# Addressing FECi TBDs

Addressing comments: 298, 304, 306, 307

**IEEE 802.3dj Plenary Meeting**

**November 12, 2024**

# Penalties for FR4 and LR4

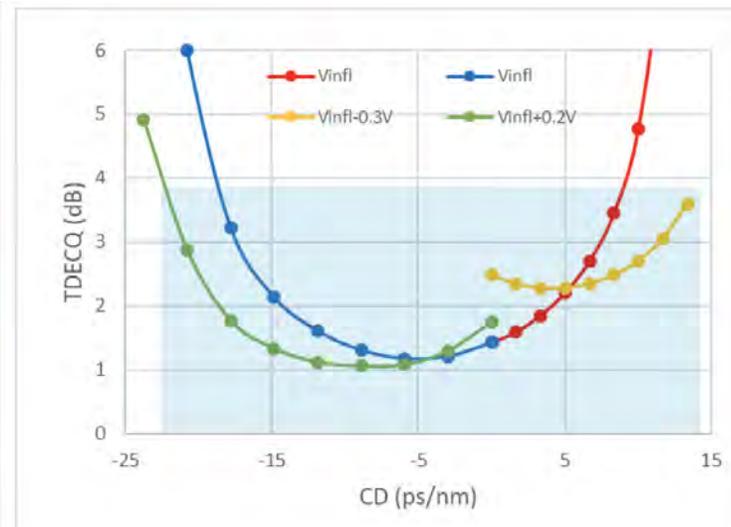
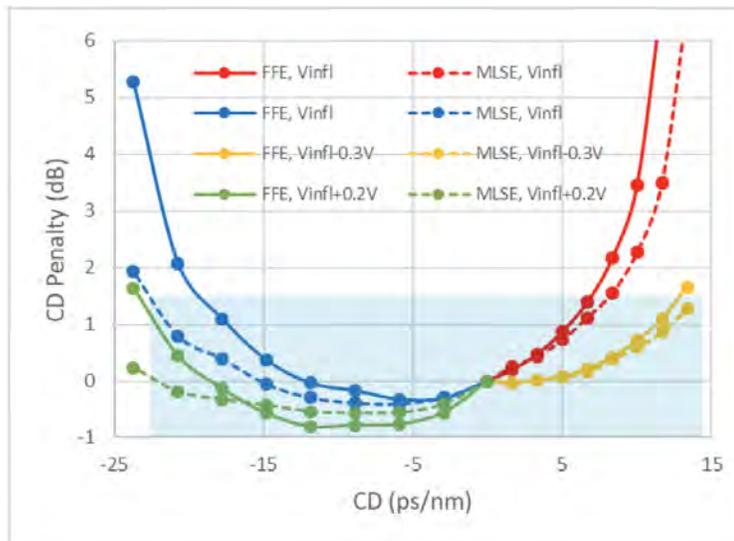
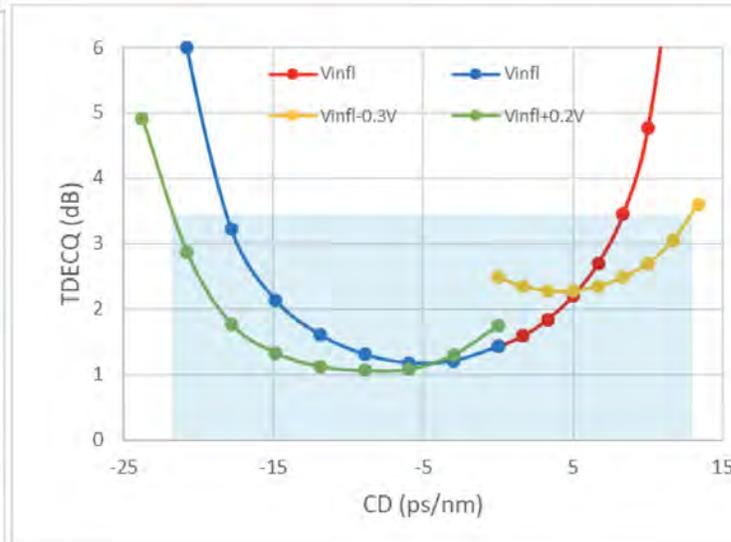
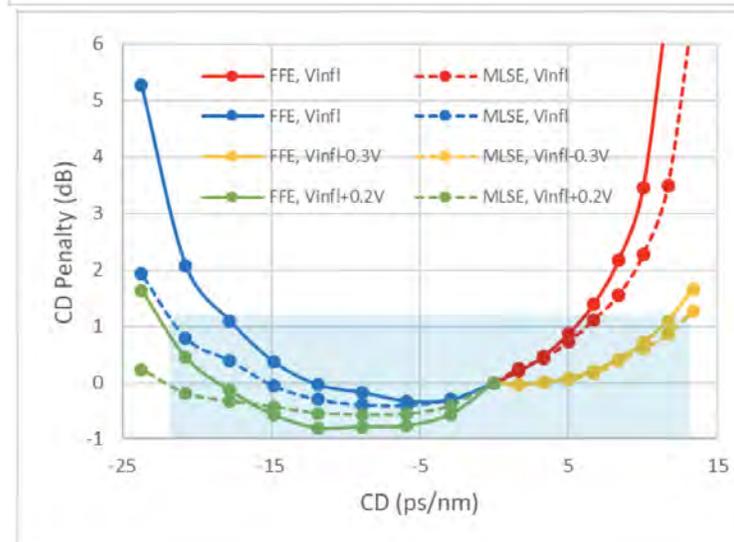
- LR4 CD range -22.2 to 14.3 ps/nm result in CD penalty of 1.5 dB and TDECQ of 3.9 dB, the current 800GBASE-LR4 has TDECQ of 3.9 dB
- CWDM CD range of -21.5 to 12.8 ps/nm result in CD penalty of 1.2 dB and TDECQ of 3.9 dB, it is reasonable to propose TDECQ of 3.4 dB for 800GBASE-FR4.

# FECi SER

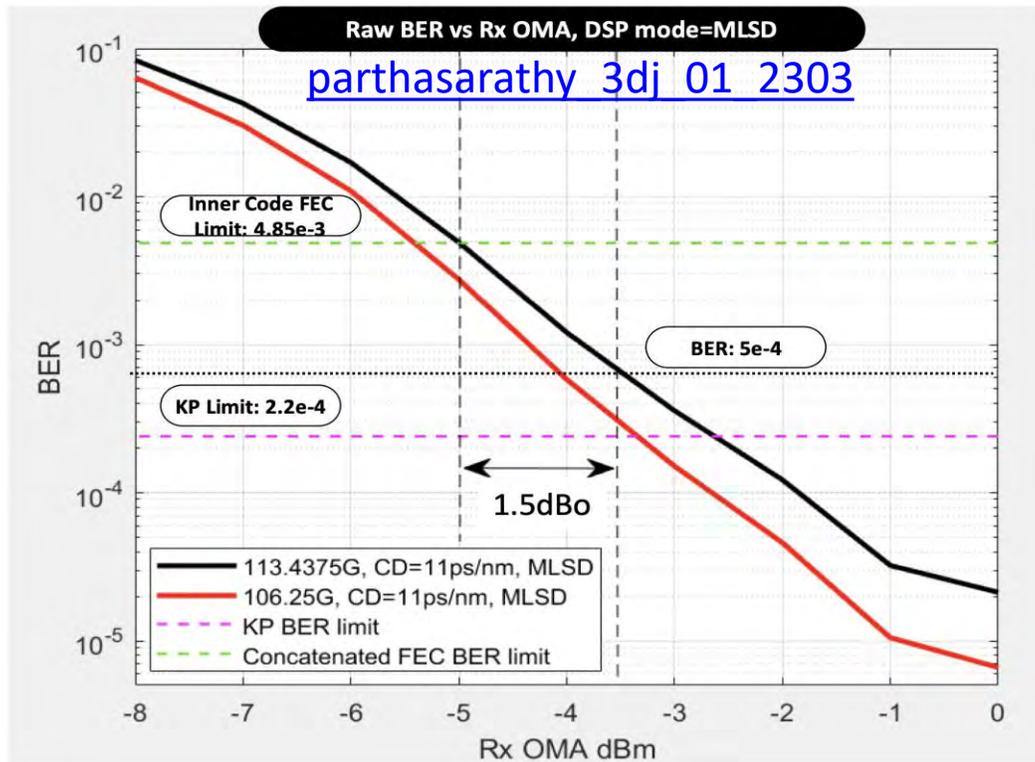
- ❑ FECi BER input OMA is close to linear in the region of interest and follows FECo response with addition of 1.5 dBo gain as shown in [parthasarathy 3dj 01 2303](#)
- ❑ [johnson 3dj optx 01 241031](#) raises concern about compression of TDECQ with higher SER, but this in line with expectation as was reported by [lecheminant 3dj 01b 2309](#)
- ❑ Based on what we know today the adopted SER 9.6E-3 is technically sound and we should not adjust SER for FECo or FECi till we have a solid proposal how to account for transmitter block errors.
